WARRANTY BULLETIN

WB15-44

DATE :	SEPTEMBER 2015	SECTION:	13 - Wheels, Hubs Tire	
EXPIRATION:	SEPTEMBER 2017			
SUBJECT :	WHEEL LUG NUTS TIGHTENING INSPECTION

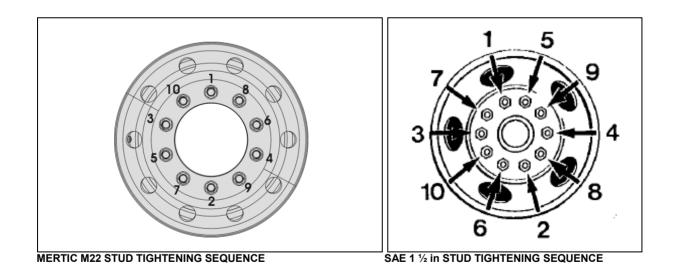
2. With a properly calibrated torque wrench and appropriately sized open box socket, check the torque value of *the lug nuts on all vehicle wheels* following the sequence shown above. Correct as necessary.

Correct torque value for all wheels: 450 to 500 ft-lb (610 to 680 Nm).
